**VILLAGE OF CHAGRIN FALLS
CEMETERY COMMISSION
August 14, 2019**

From: C. McGinnis, P.E.
To: Tim Lannon, Village Engineer
CC: John Lillash
Subject: Summary of Cemetery Building Review (19000601, Ph-07)
Location: Evergreen Hill Cemetery, Chagrin Falls, OH
Reason: Transformation of Existing Structure Into a Vault Columbarium (By Others)
Observation Date: 7/16/19
Observation By: C McGinnis & John Lillash

DOWEL/PIN
HOLES; TYP

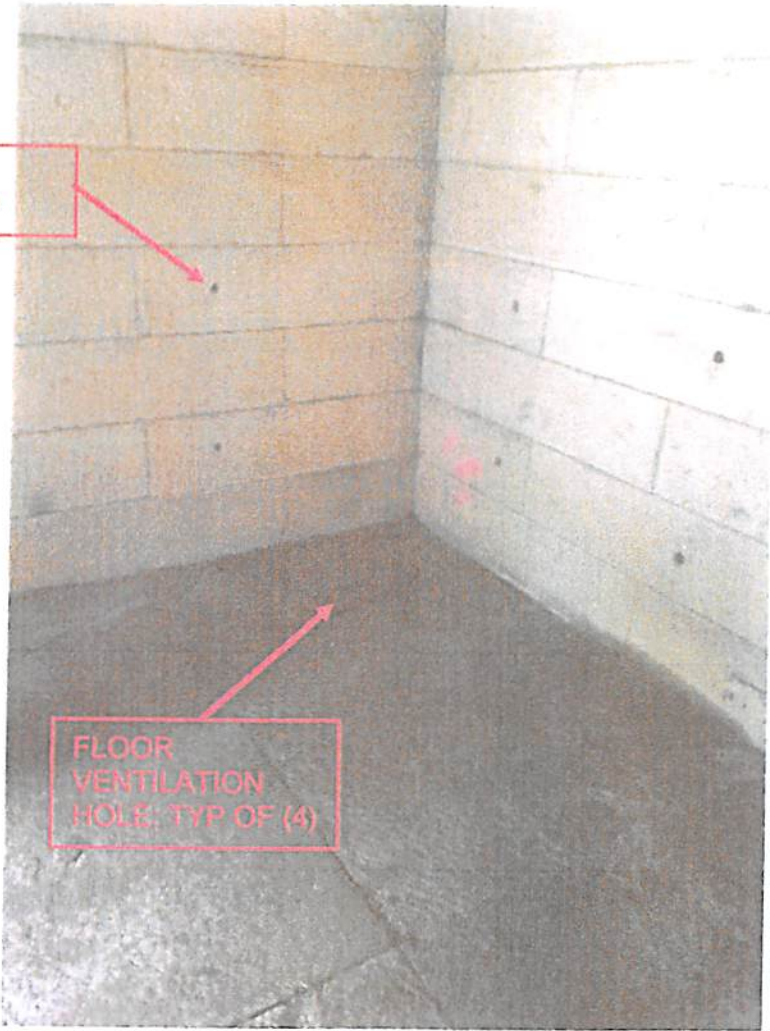
- Solid 18" thick block/mortar walls with front double leaf caged entrance door, no window openings and (2) 6" dia. foundation ventilation openings at each end of both long walls. The interior face of the second and fourth masonry courses contained 1 ½" dia. holes, 8"-9" deep, at approximately 2' spacing which are understood to be dowel/pin support holes for removable mortuary tables.

FLOOR
VENTILATION
HOLE; TYP OF (4)

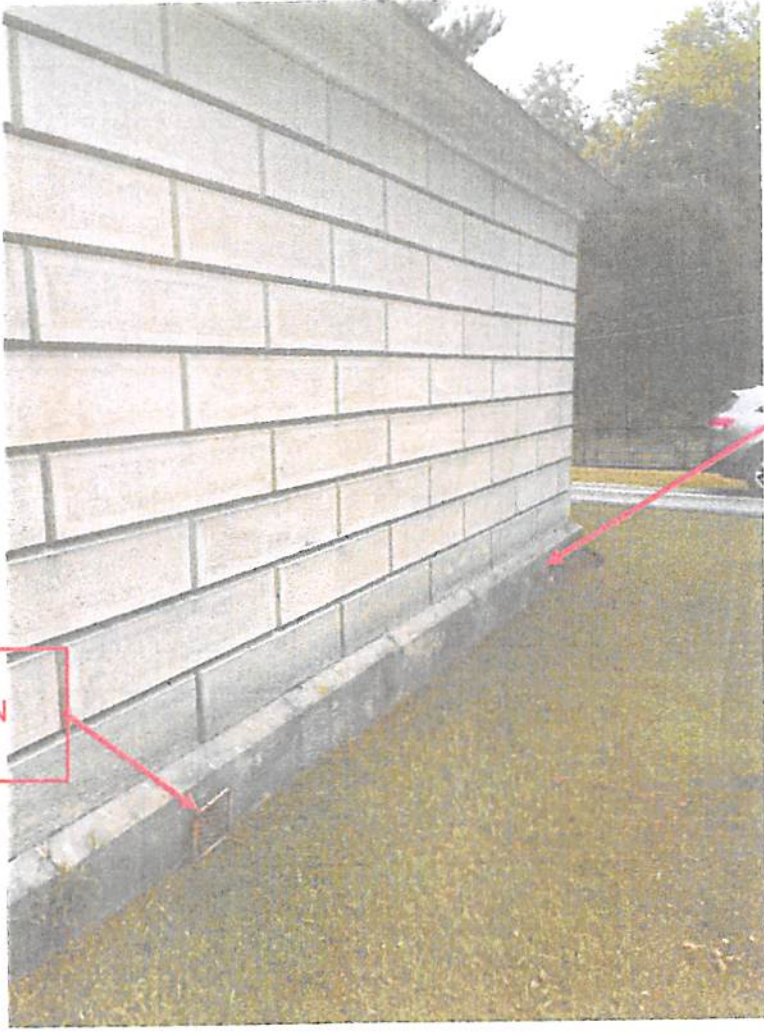
- Interior floor consisted of (8) individual 5.0'x6.5'± flat slabs of 4.5" ± thick stone above an apparent 18" ± air cavity. The four corner slabs contained an 8" ± sq. ventilation opening approximately 24" in from each corner to the underlying void beneath the slab which was in turn vented through the foundation to the exterior of the building.

- Fill underlying air cavity with LSM (Low Strength Mortar) following owner installation of conduit below the slab, noting that the current ventilation openings be maintained via sleeves through the existing wall and slab openings, prior to LSM placement.

LOOSE
VENTILATION
GUARD

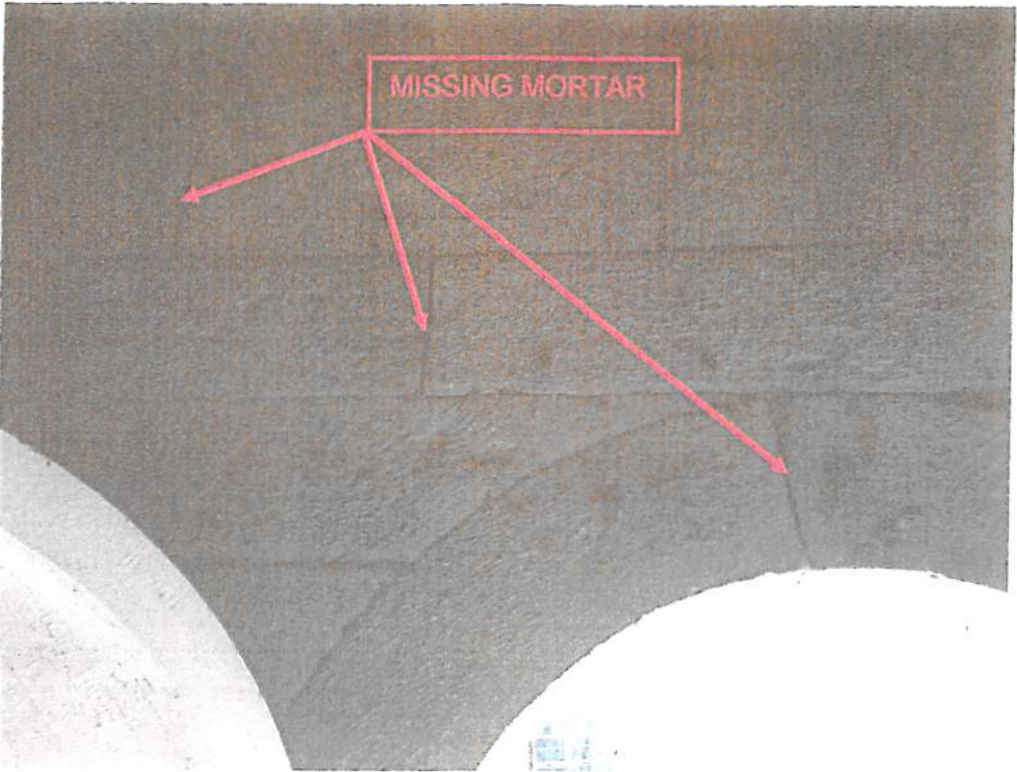
- Exterior foundation ventilation openings require louvered covers for rodent control.
- Interior bead board ceiling contained a couple of demolition/access holes that require patch/repair.
